Access Compliance Report

Public Rights-of-Way

(Curb Ramps)

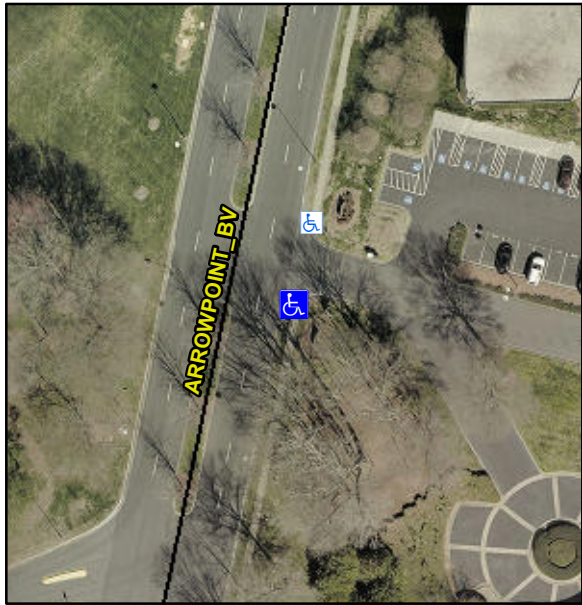
Intersection ID: 10020012		Main Street: ARROWPOINT_BV		Cross Street: N/A		Location:		SE			
ADA ID: D68D3750642B		Ramp Type: Directional2		Initial Pass/Fail: Fail		Overall Compliance: No		Severity Score: 37.5			
Codes/Mitigation Info/Possible Solution				Field Measurements/Component Compliance							
				Possible Solutions:		Compliance		Description		Data	
				Remove & Replace Entire Ramp.		N/A		Ramp Length (in)		80.0	
Surveyor Notes:				N/A		Yes		Ramp Width (in)		48.0	
						No		Ramp Slope (%)		14.3	
PROW/ADA:				R304.2.2, R304.5.3		No		Ramp XSlope (%)		6.0	
						N/A		Flare Type LT		N/A	
						N/A		Flare Slope LT (%)		N/A	
						N/A		Flare Traversable LT?		N/A	
						N/A		Landing Length (in)		0.0	
						N/A		Landing Width (in)		0.0	
						N/A		Landing Slope (%)		0.0	
						N/A		Landing X Slope (%)		0.0	
						N/A		Landing Curb? (Y/N)		N/A	
						N/A		Shared Landing?		N/A	
						N/A		Gutter Ponding?		0.0	
						N/A		Gutter Lip Ht (in)		0.0

N/A		Painted X Walk1?		No	
						N/A		X Walk 1 Direction		To N	
						N/A		X Walk 1 Width (in)		N/A	
						N/A		X Walk 1 Slope (%)		0.7	
						N/A		X Walk 1 X Slope (%)		11.6	
						N/A		Ramp inside XWalk1?		N/A	
						N/A		Any Obstructions?		N/A	
						N/A		Obstruction Type		Yes	
						N/A		Surface Condition? (G/P)		Good	
						N/A		Curb Slope (%)		3.1	
Street 1 Name		ENTRANCE									
Stop Condition-Street 1		StopSign									
Street 2 Name		N/A									
Stop Condition-Street 2		N/A									
Total Cost:		\$		1800.00

PROW/ADA:

R304.2.2, R304.5.3

Possible Solutions:

Remove & Replace Entire Ramp.
